PRAIRIE ISLAND NUCLEAR GENERATING PLANT  
Docket Nos. 50-282 License Nos. DPR-42  
50-306 DPR-60

Response to the Heavy Loads Phase II  
Technical Evaluation Report

Response to The Heavy Loads Phase II  
Technical Evaluation Report

FIGURE 1

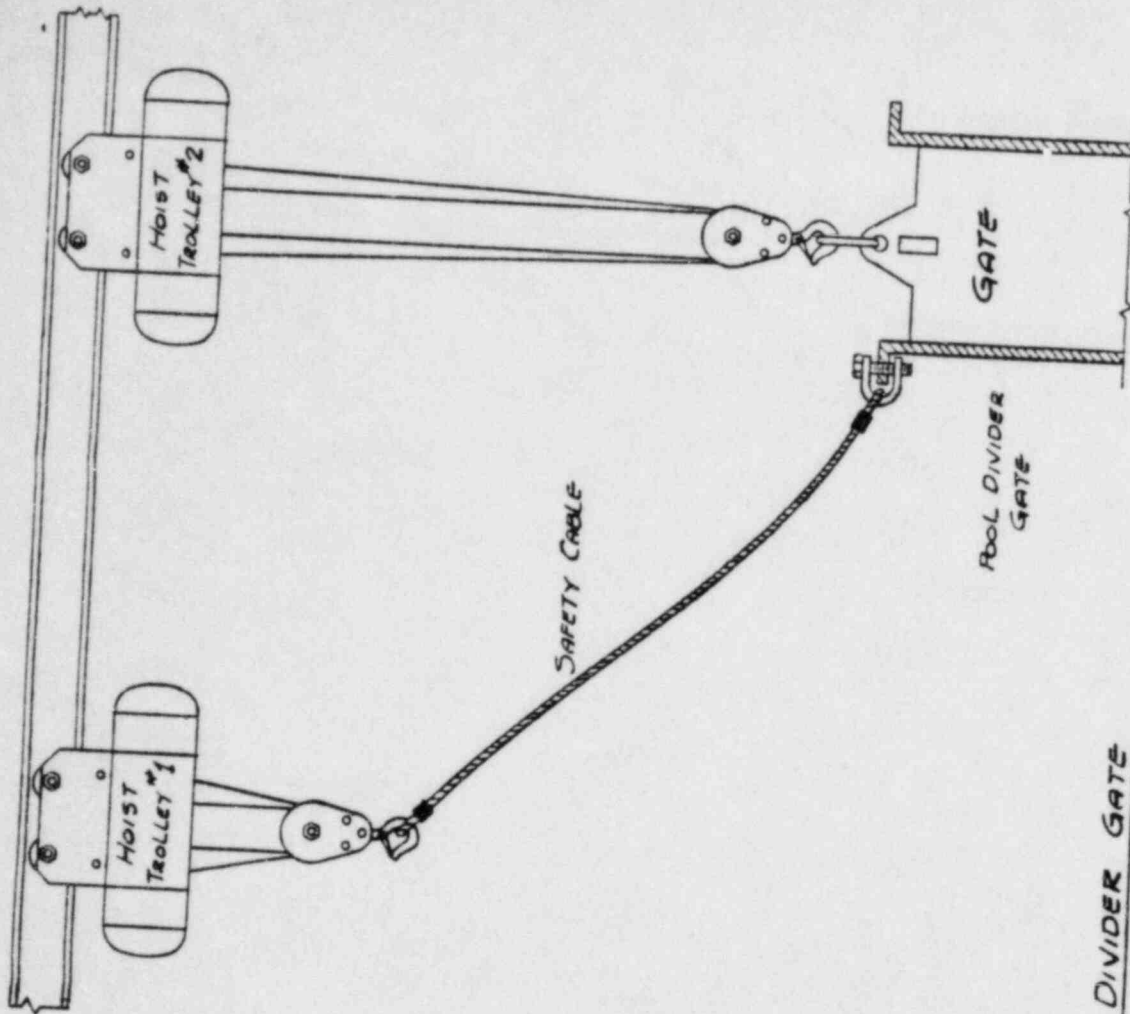
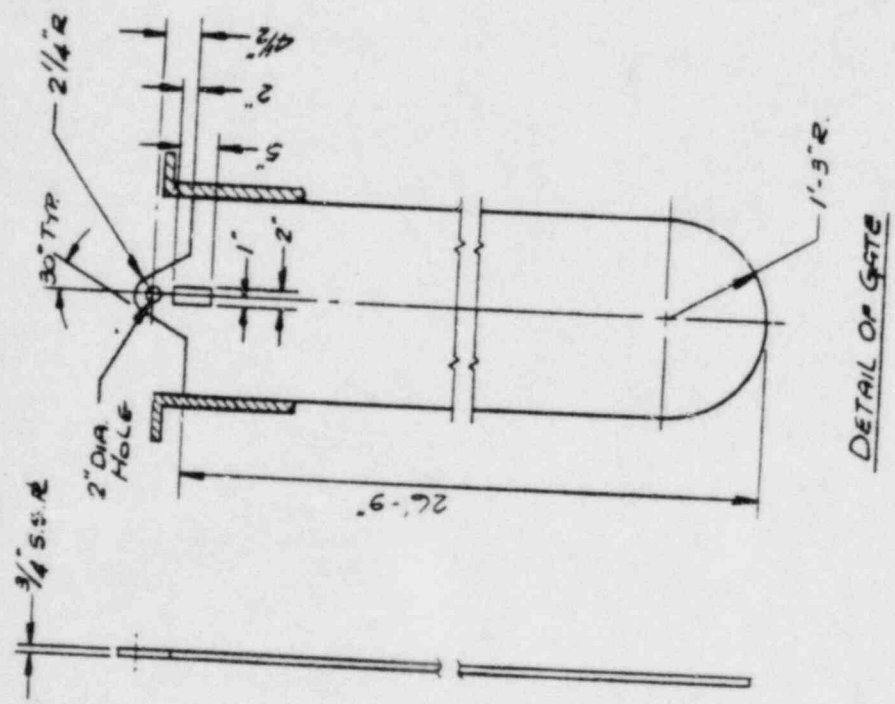
Clarification was requested on the methods used to handle the spent fuel pool divider gates and the spent fuel pool covers.

Figure 1 illustrates the method used to handle the pool divider gates. As shown, two separate trolleys are used to handle the gate. Each trolley has a 3-ton capacity. Failure of one trolley system will not result in the dropping of the divider gate.
